Our Case Number: ABP-317767-23

Re: Proposed construction of 39 residential units, widening of Pausdeen Bridge and all associated site works.
Newtown/Ardclough Road, Newtown, Celbridge, Co. Kildare.

Planning Observation Submissions to An Bord Pleanála

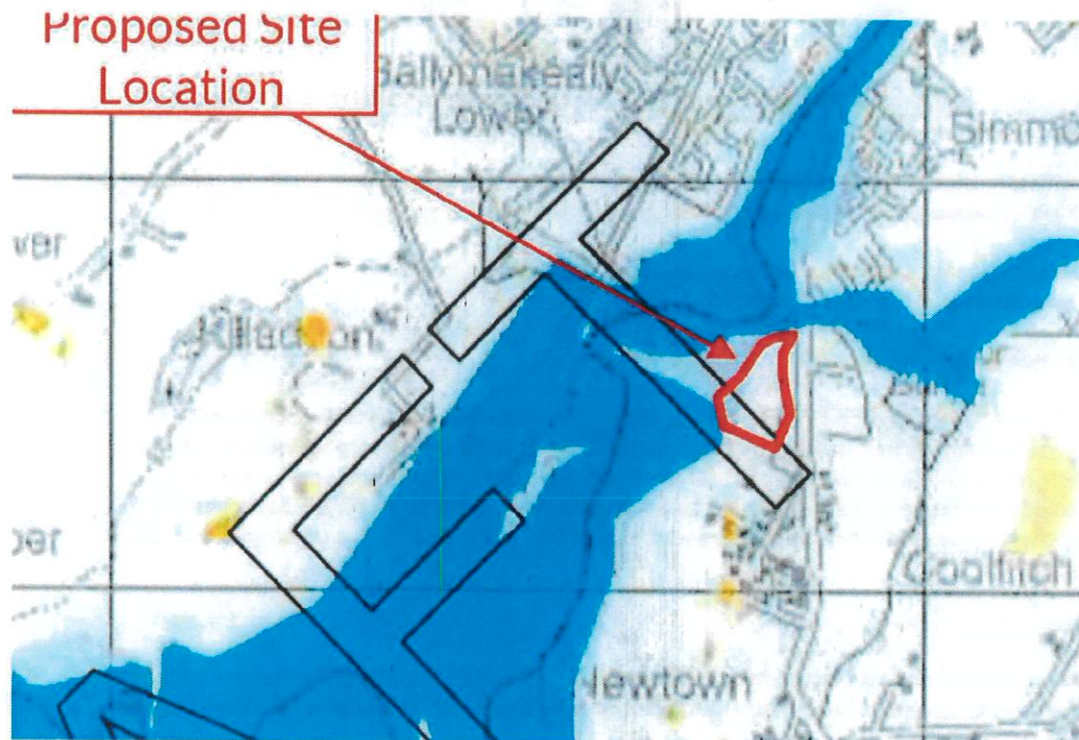
Very little tolerance: The predicted high water level of the site at 09LIFF02820 and 0.1% AEP is 52.95m. However evidence shows water further into the site. The Topographical survey indicates a North Western Fall

with levels varying from 53.80 to 53.0m OD at the Northwestern Edge. Are we to assume therefore that it was the illegal dumping which has helped to raise the site? Also 5cm clearance from a map without empirical current site data is hardly reassuring as good tolerance to flooding.
